LANDSCAPE RESPONSE

COUNCIL COMMENTS

LAND AT WITHINGTON COURT, WITHINGTON, HEREFORD, HR1 3SB

PLANNING RECONSULTATION REF: 200207

Revision
B

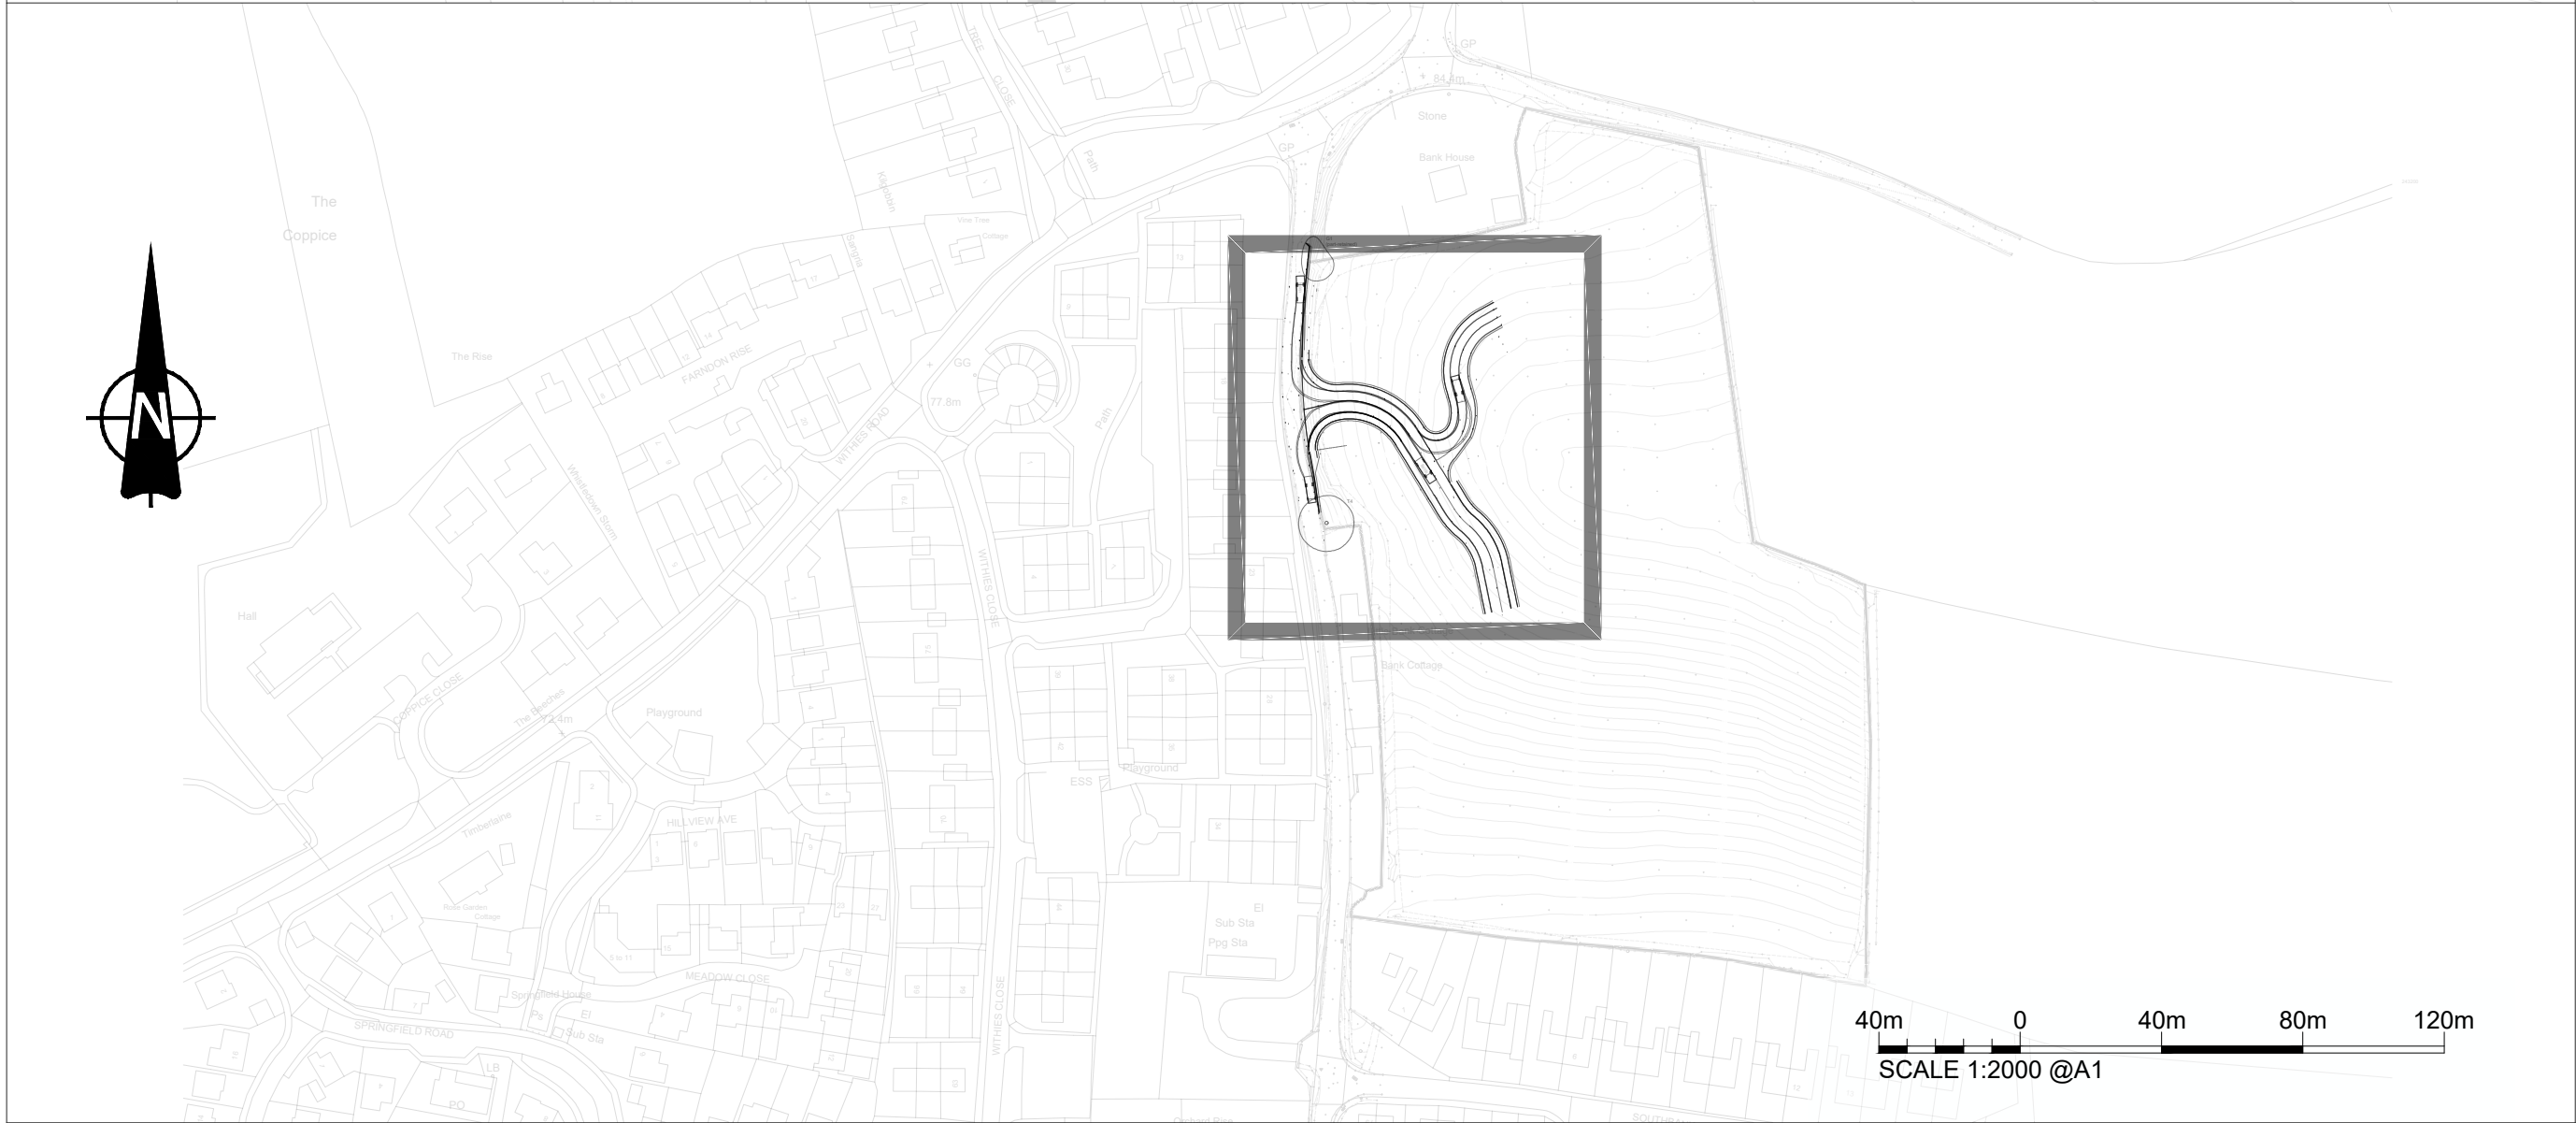
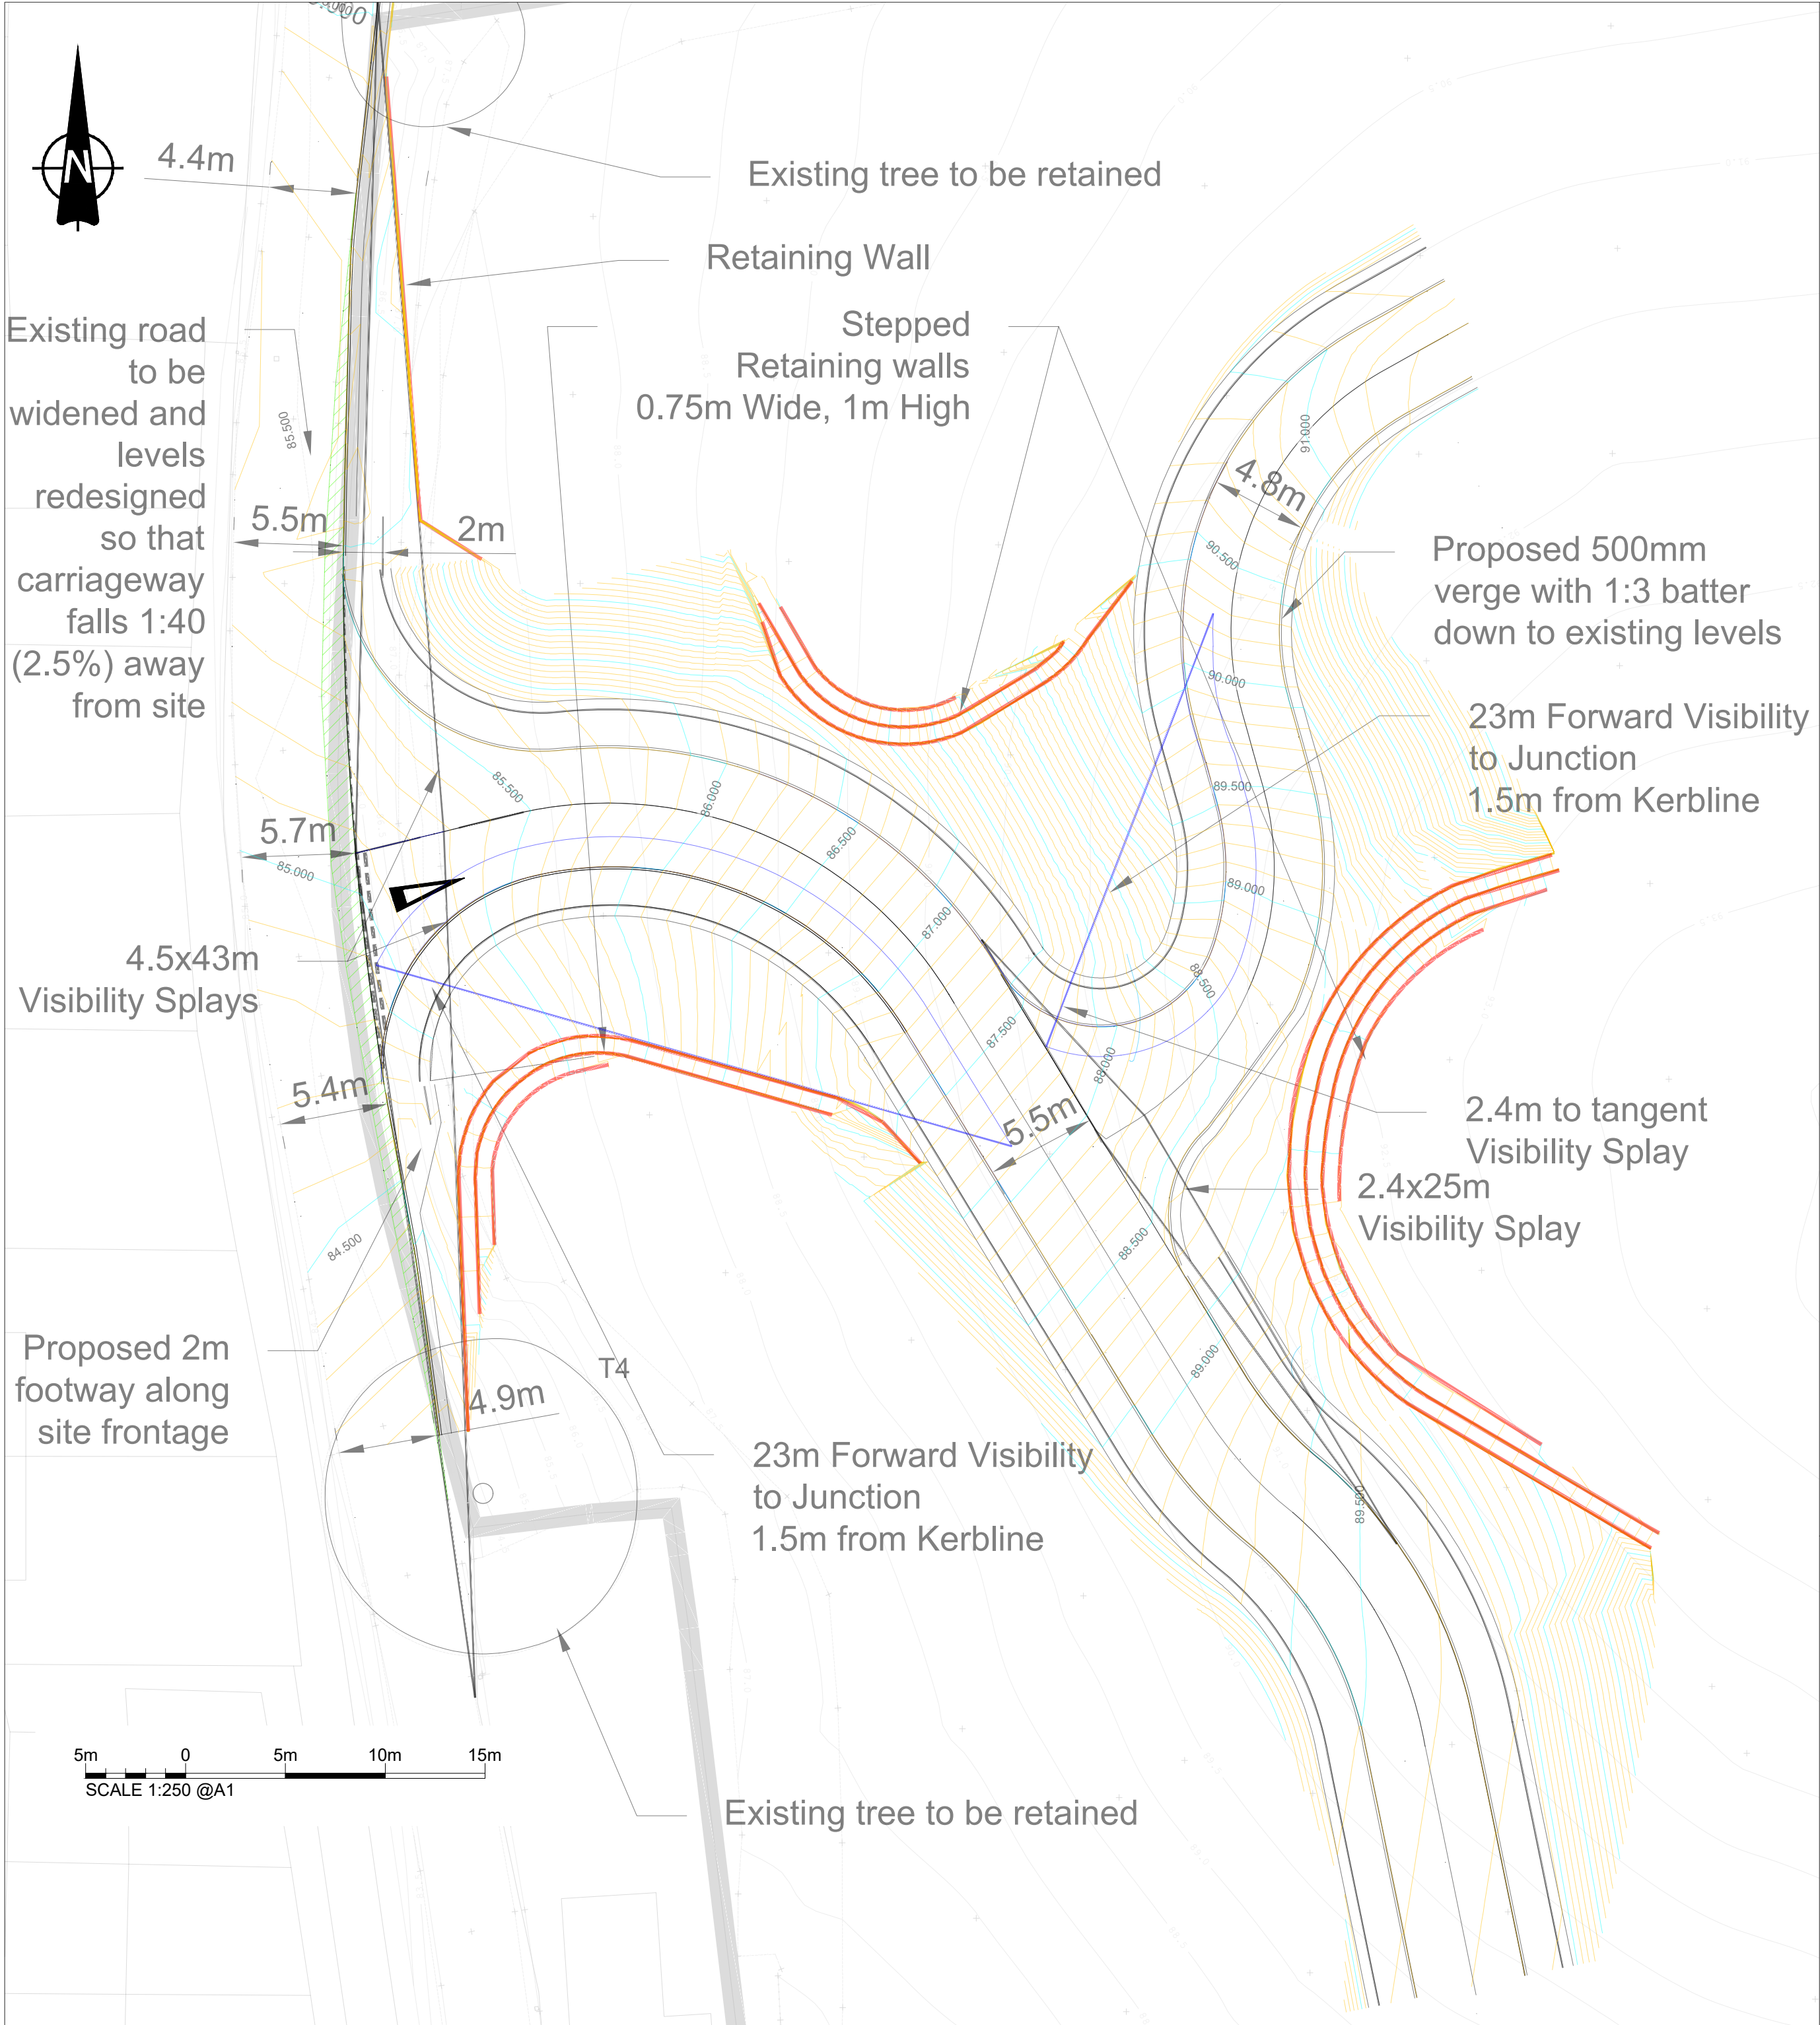
- 2.2 *The applicant has shown conceptual drawings that includes the intention to ‘soften’ the highway engineer’s retaining walls for the access (This is the preferred approach). However, to fully appreciate the removal of the retaining walls and how the levels and gradients look, and if this impacts the planting structure, the landscape drawings and engineering drawings would need to be coordinated... Further information of the ‘actual’ proposal is required.*

- 2.4 *The planting plan looks interesting as a zonal pattern, but how does it respond with actual species, densities and canopies? How does it respond to sight lines and vehicle visibility splay? And how does it respond to the levels, once the retaining walls are removed?*

2.6 ***The native species woodland mix (the zone next to the footpath) is relatively narrow and therefore in essence is a hedge. The species mix includes thorny species, and needs to be considered carefully next to a footpath. Please refer to the Herefordshire Council, Highway Design Guide for New Development, under 2.14 Landscaping, that states ‘Thorned species shall not be accepted immediately adjacent to footways or cycle tracks’ and review the species list accordingly.***

2.8 ***Regarding specimen trees, to make the sense of arrival more desirable, it may be worth considering locating these trees closer to the main access.***

- 2.3 The drawings at **Appendix C** are now updated to show a fully co-ordinated approach as to how the site gradients and the planting design would work in combination to deliver a well-designed solution for the new Site access. The drawings propose a series of stepped gabion retaining structures combined with new ground cover planting to naturalise the gabions and provide a softer appearance. The planting allows for ground cover to cascade from the upper areas over the gabion structures, the lower areas would also be planted as well as some planting pockets within. The tree planting has also been re-configured to accord with the new layout and help soften the effects of the gabion structures at the Site entrance.

- 2.5 Sight lines and visibility splays are now shown on the revised plans at **Appendix C** for fuller clarity. The proposed levels are also shown along with planting species and densities. In terms of tree canopies the design intention would be to create a layered structure to place the trees with the tallest canopies within the central regions of the planting zones, then stepping down towards the peripheral areas with a graduation towards an understorey layer including evergreen species at the edges of the planting zones. The planting design would be specifically arranged and species selected to create an informal, wooded character to the access road and to reduce visibility in all seasons in views towards the new housing from the

2.7 We have taken this requirement into account and revised the design to ensure that these thorny species are not positioned adjacent to footways. In addition, the planting specification on the drawing also notes that “*the final canopy of any thorned should be plant at least 3 metres from the edge of footways or roads*” as per the *Herefordshire Council, Highway Design Guide for New Development (July 2006)*.

2.9 This has been considered and several trees have been moved closer to the main access road. Refer to the Landscape Planting Concept Plan (**Appendix C**) which show species such as English Oak, English Elm, Rowan, Alder and Wild Cherry positioned closer to the Site frontage designed to provide an interesting combination of flowers in spring and fruit in autumn.
